Intersection ID: 14441	Main Street: E_KINGSTON_AV	Cross Street: SPRINGDALE_AV	Location:	S
ADA ID: 25BDAF2877F7	Ramp Type: Perp	Initial Pass/Fail: Fail	Overall Compliance: No	Severity Score: 13.75

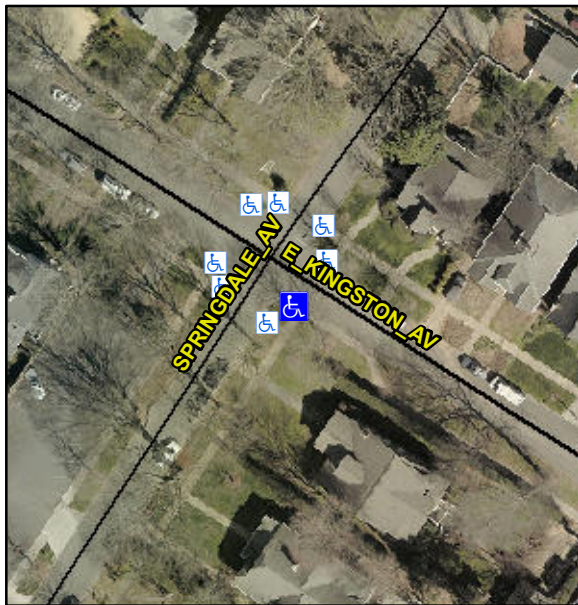
Not Found, R304.2.2, R304.5.3

Compliance	Description	Data	Compliance	Description	Data
N/A	Ramp Length (in)	65.0	No	Ramp Slope (%)	10.2
Yes	Ramp Width (in)	49.0	No	Ramp XSlope (%)	2.3
N/A	Flare Type LT	N/A	N/A	Flare Type RT	N/A
N/A	Flare Slope LT (%)	N/A	N/A	Flare Slope RT (%)	N/A
N/A	Flare Traversable LT?	N/A	N/A	Flare Traversable RT?	N/A
N/A	Landing Length (in)	N/A	N/A	DWS Provided?	N/A
N/A	Landing Width (in)	N/A	N/A	DWS Contrast?	N/A
N/A	Landing Slope (%)	N/A	N/A	DWS Length (in)	N/A
N/A	Landing X Slope (%)	N/A	N/A	DWS Full Width?	N/A
N/A	Landing Curb? (Y/N)	N/A	N/A	DWS Offset (in)	N/A
N/A	Shared Landing?	N/A			
N/A	Gutter Ponding?	Yes	N/A	Gutter Slope (%)	N/A
N/A	Gutter Lip Ht (in)	N/A	N/A	Gutter X Slope (%)	N/A
N/A	Painted X Walk1?	No	N/A	Painted X Walk2?	N/A
	X Walk 1 Direction	To NE		X Walk 2 Direction	N/A
N/A	X Walk 1 Width (in)	N/A	N/A	X Walk 2 Width (in)	N/A
	X Walk 1 Slope (%)	4.1		X Walk 2 Slope (%)	N/A
	X Walk 1 X Slope (%)	1.5		X Walk 2 X Slope (%)	N/A

Remove & Replace Entire Ramp.
